**HISTORIC PRESERVATION COMMISSION
WORK SESSION
AUGUST 12, 2020
ASSEMBLY HALL
395 MAGNOLIA ROAD
PINEHURST, NORTH CAROLINA
11:30 AM**

PLANNING AND INSPECTIONS DEPARTMENT STAFF REPORT

To: Historic Preservation Commission
From: Peter Hughes, Senior Planner
CC: Darryn Burich, Planning and Inspections Director
Kelly Brown, Administrative Specialist
Date: August 20, 2020
Subject: Major COA Request for 55 Shaw Road (COA-2020-00098)

To: Historic Preservation Commission
From: Peter Hughes, Senior Planner
CC: Darryn Burich, Planning and Inspections Director
Kelly Brown, Administrative Specialist
Date: August 20, 2020
Subject: Major COA Request for 41 Shaw Road (COA-2020-00099)

Plan Elevation
4/1/20

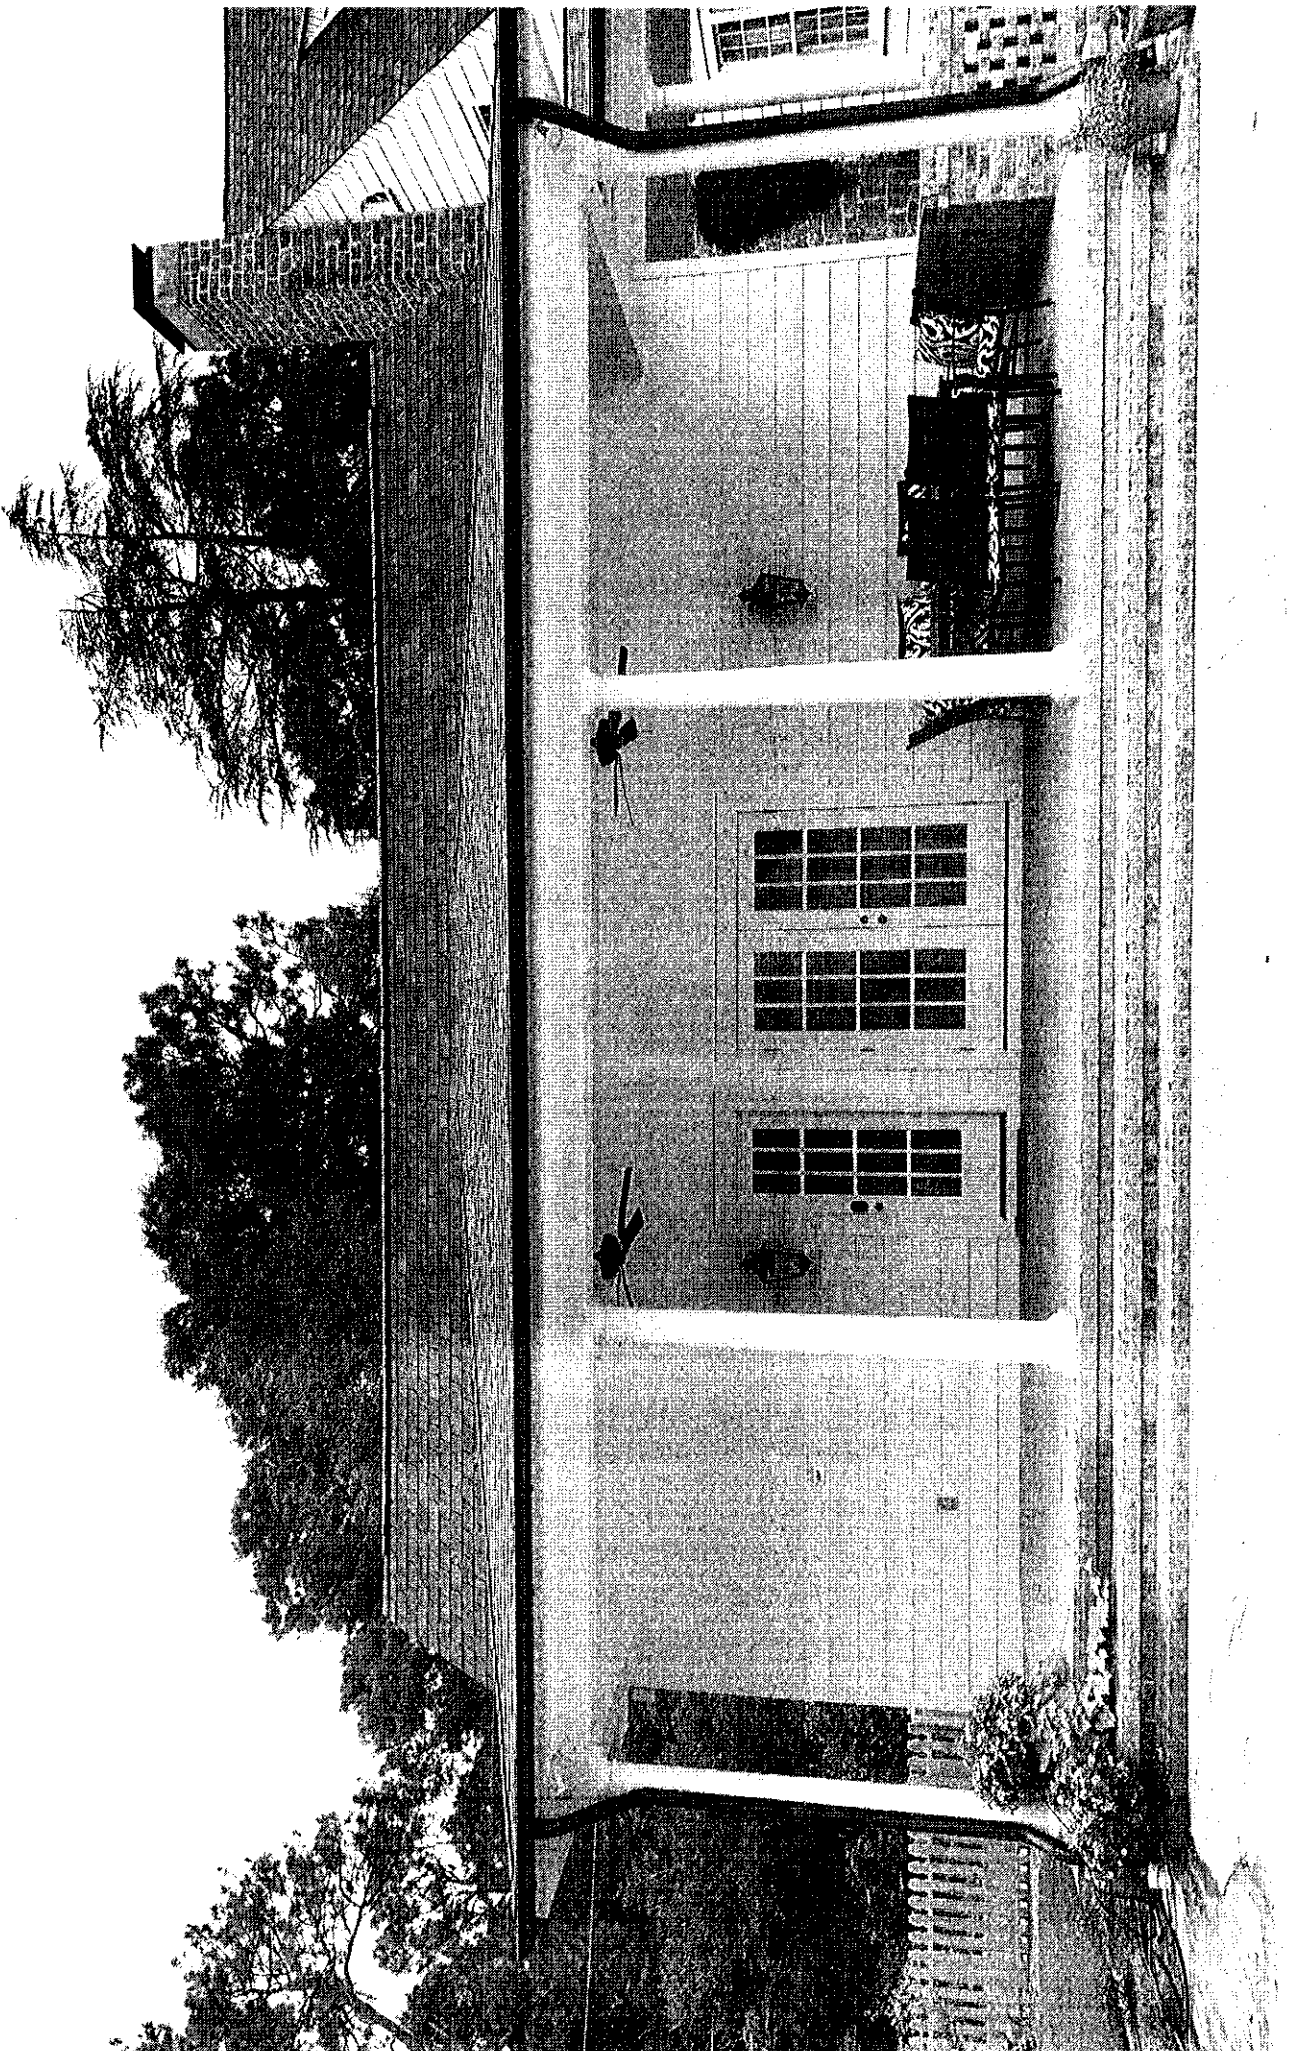
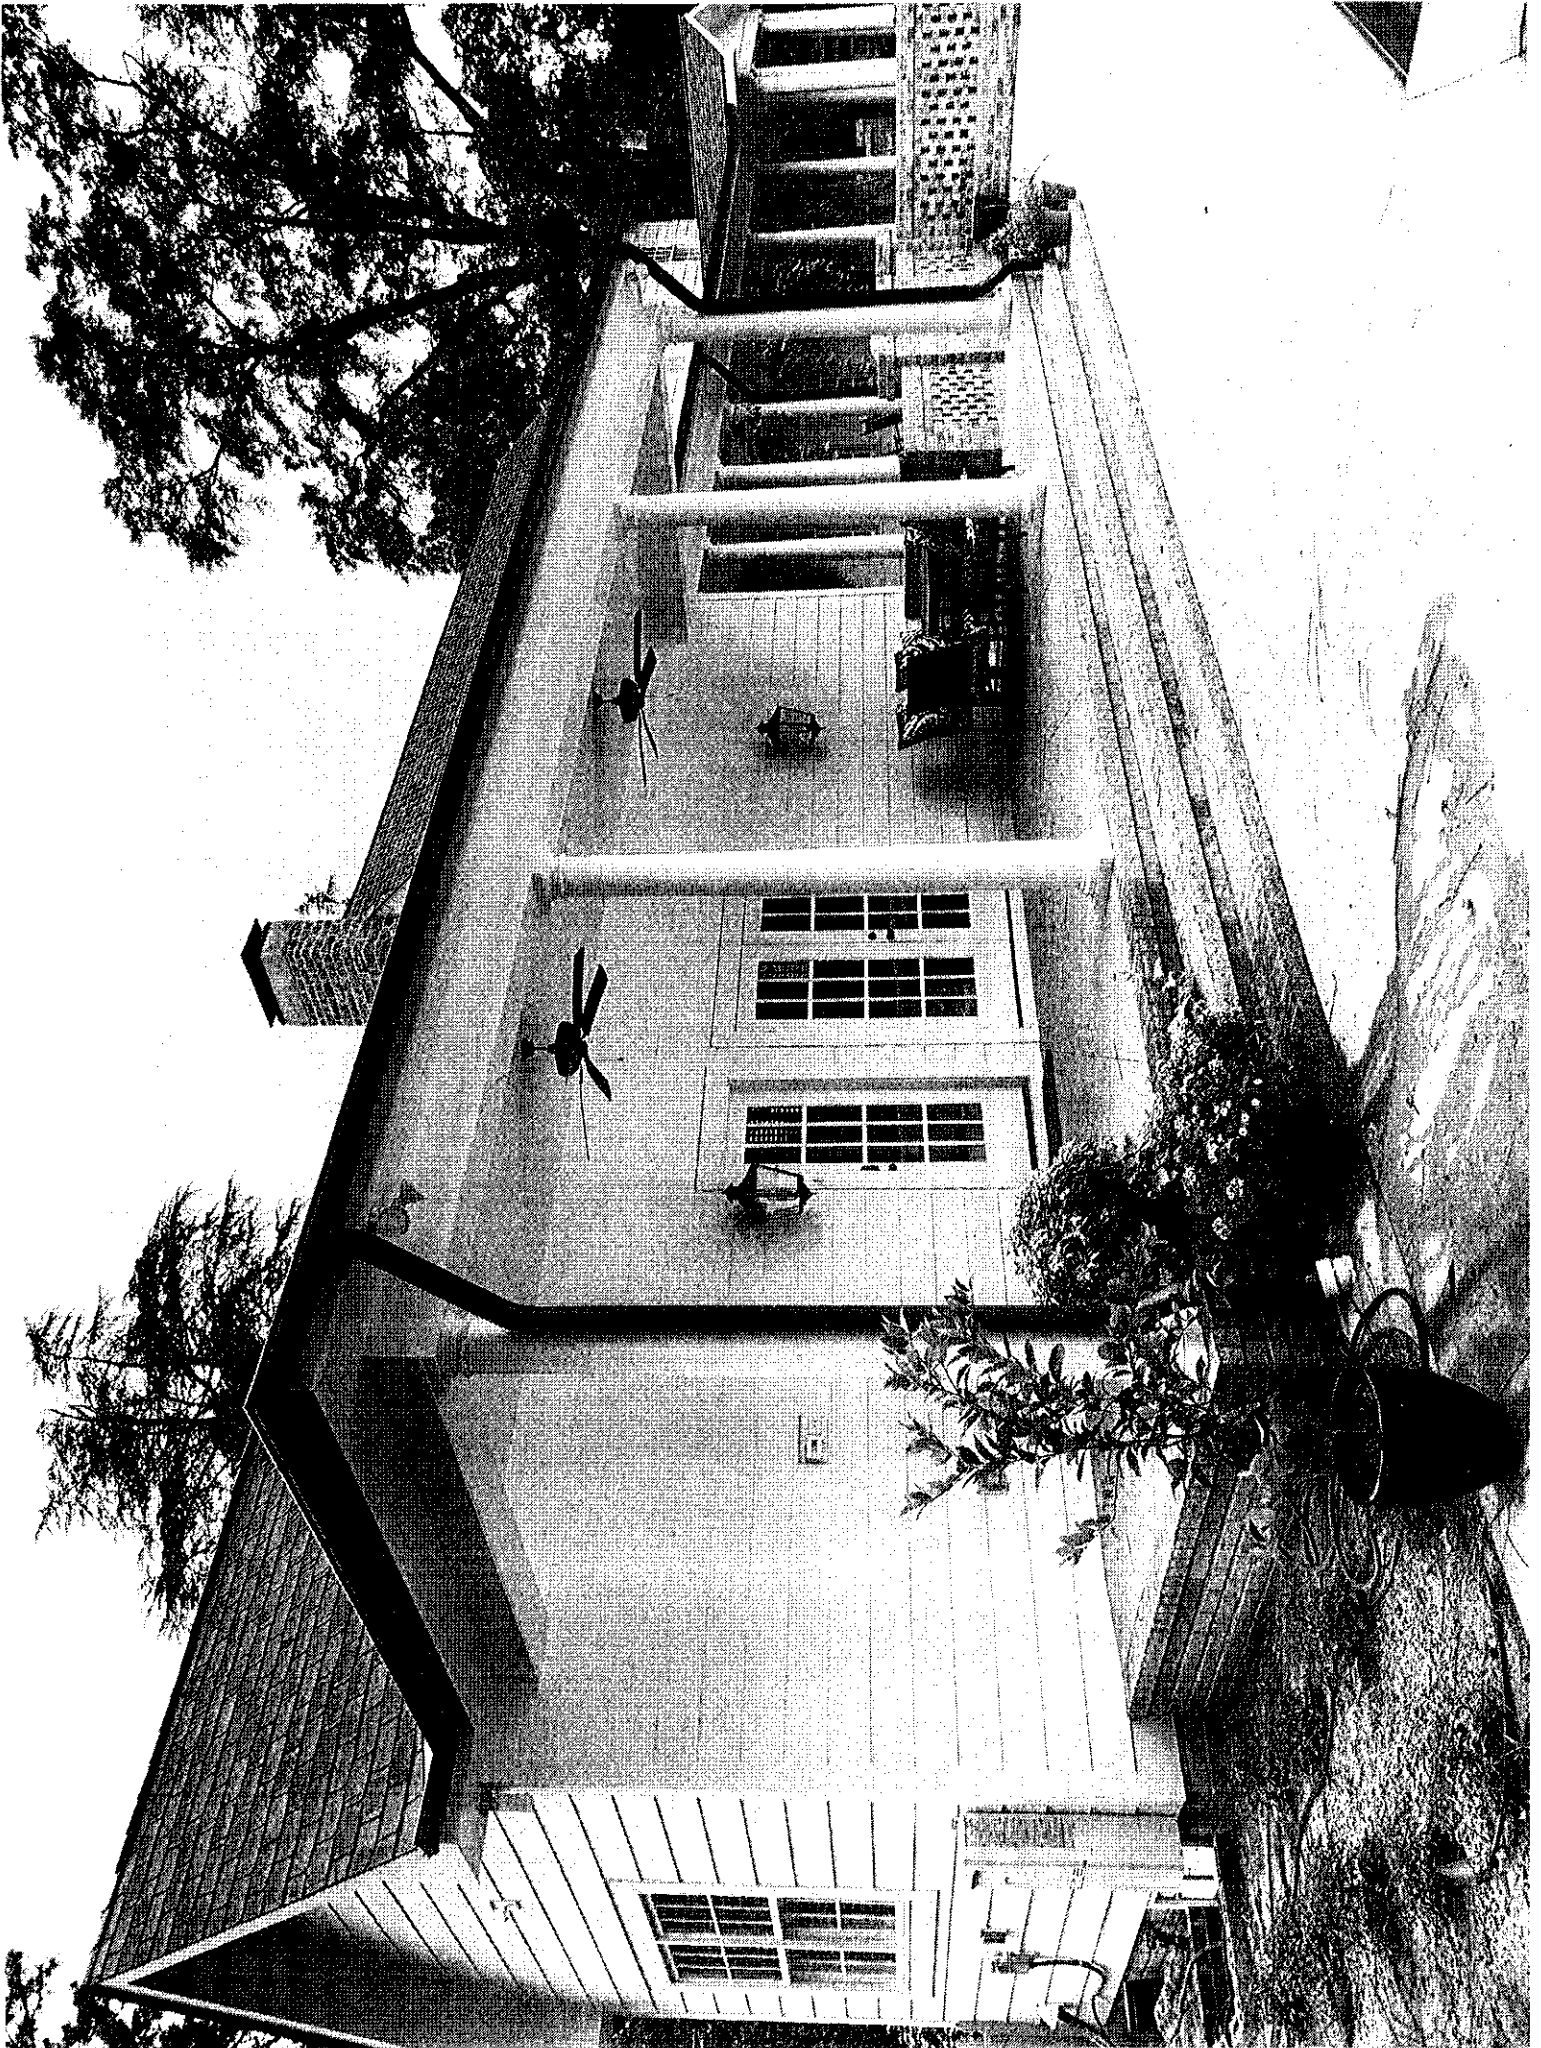
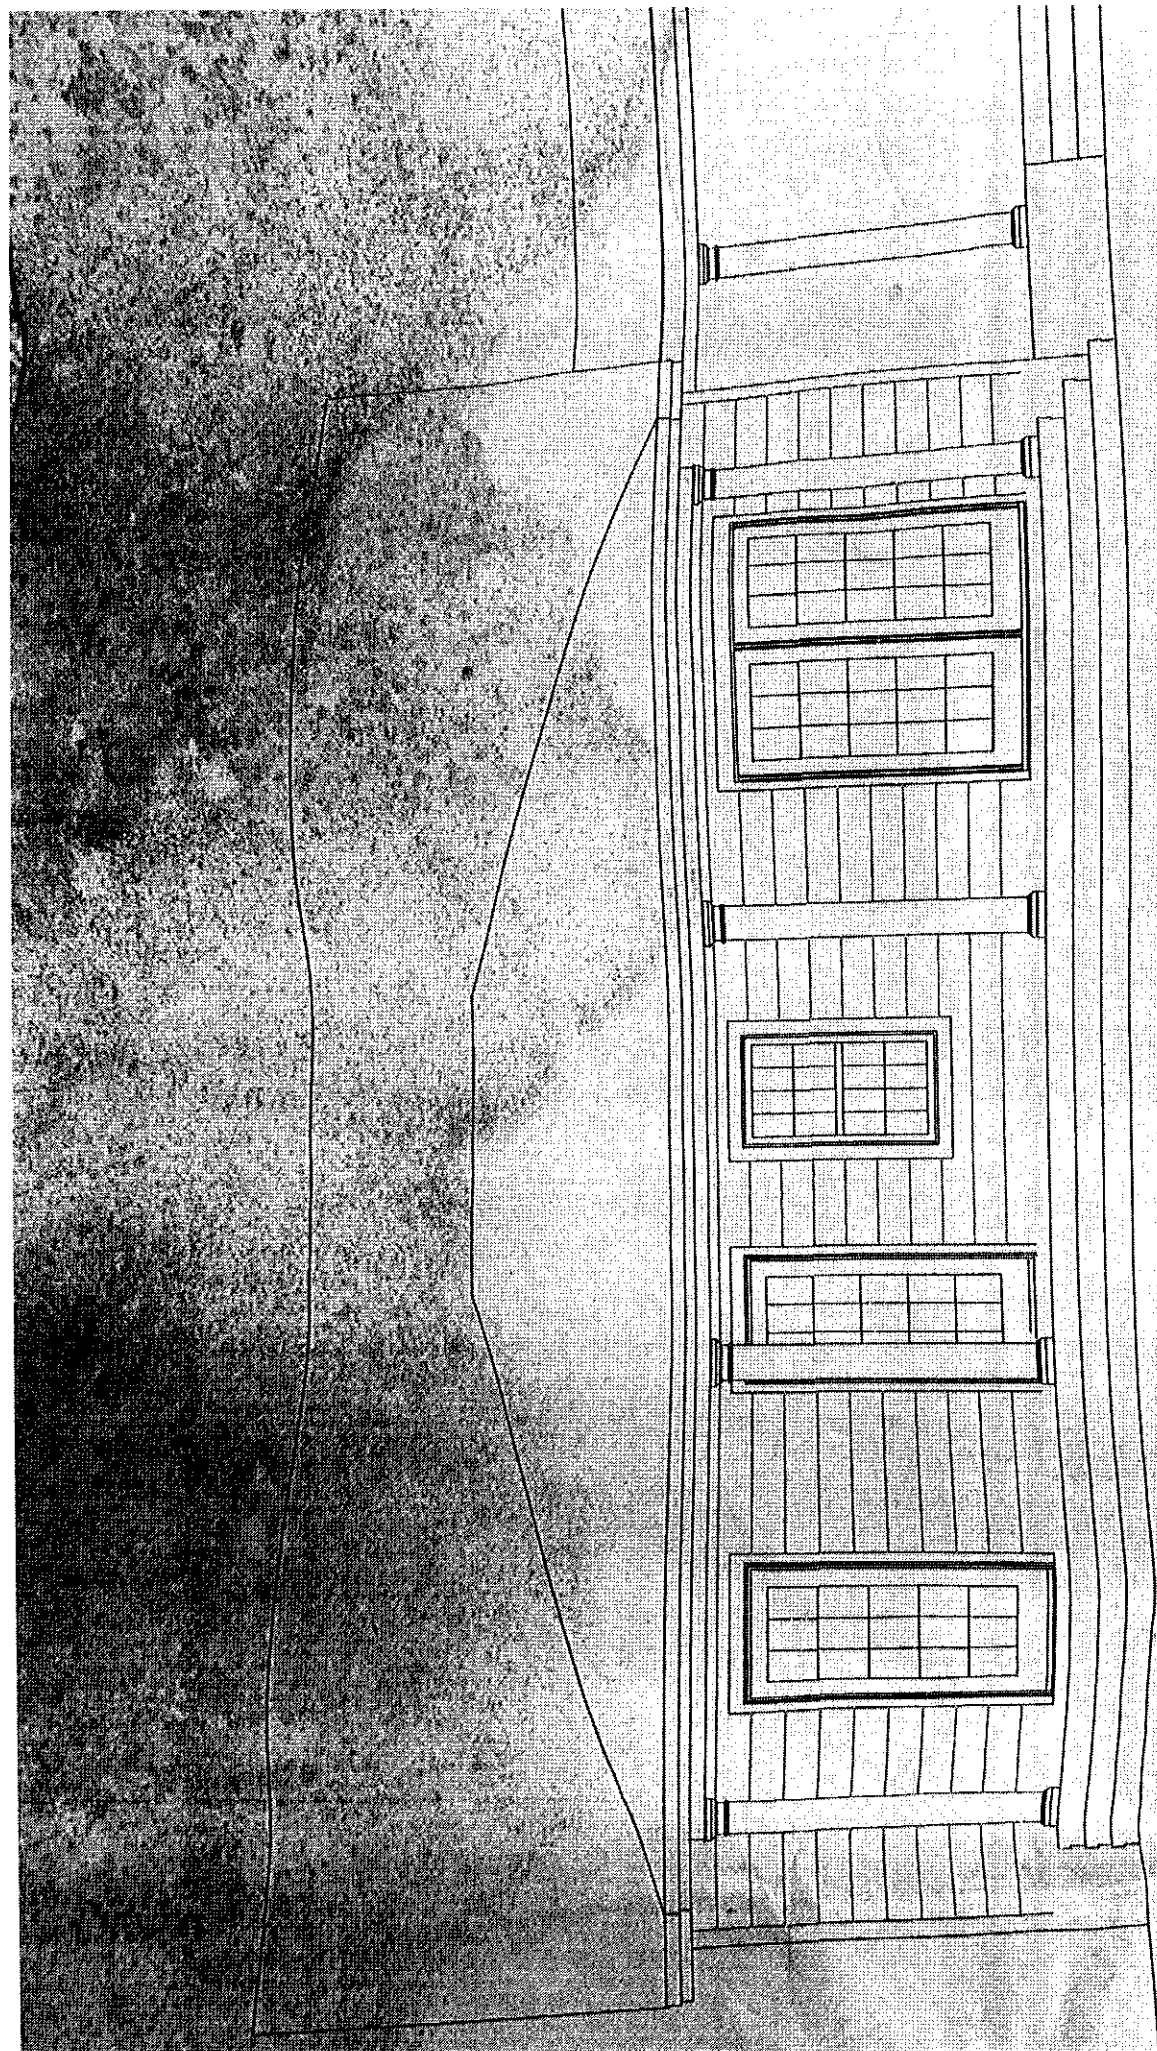
The 2020 design for the guest cottage appears to be more architecturally compatible with the primary residence because the primary residence elevation show even spacing between openings and none of the porch columns obscure any of the fenestration. In addition to being more architecturally compatible, the 2020 design would also appear to still be congruous with other guest cottages and pool houses within the Historic District.

The April 2019 approved plans illustrated one window and four glass doors on the rear façade of the guest cottage. The 2020 photo of the guest cottage shows no windows and three glass doors on the rear façade. The fenestration was reduced by one window and one door and the arrangement of the door layout was alter from what was approved. The change in number of openings does not compromise the architectural character of the structure. The changes occurred on the rear elevation and because of the topography and landscaping of the lot, these changes are difficult to see from the street. The front façade (streetscape) maintained a high volume of fenestration and the structure remains congruous with other accessory dwellings within the Historic District.

Staff believes this request is in conformity with the Guidelines and recommends approval of this modification to a previously approved COA.
